SERVICE BULLETIN NOTICE – MOELLER MARINE PRODUCTS

LP Portable Fuel Tanks

Part Numbers: 620003LP, 620048LP, 620048LP-PAL, 620049LP

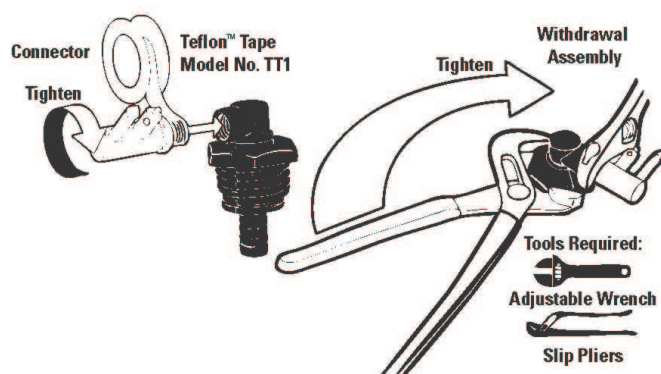
Moeller Marine Products has discovered that the hang tags for the 3 and 6 gallon Low Permeation Portable Fuel Tanks are missing a set of instructions on the back of the tag. This set of instructions will guide the customer to correctly install connectors and ensure the 360° withdrawal assembly is tight. Without the instructions, it is possible for the customer to have a connector or withdrawal assembly installed on their tank improperly which could result in a potential leak. The instructions for proper installation are below. The use of Teflon Tape on the connector will help ensure a proper seal. It is also important once the withdrawal assembly is oriented into the desired position that the customer tightens the withdrawal assembly.

Note: For ease of installation Withdrawal Assemblies are not tightened down when shipped.

1. Ensure tank is empty.
2. Remove Withdrawal Assembly from the tank.
3. Apply Teflon™ tape to threads on Connector.
4. Hand tighten the Connector to the Withdrawal Assembly, then tighten another 1/4 turn with wrench.
5. Hand tighten the Withdrawal Assembly to the tank, then tighten another 3/4 of a turn with slip pliers while holding the Connector in the desired direction with wrench.
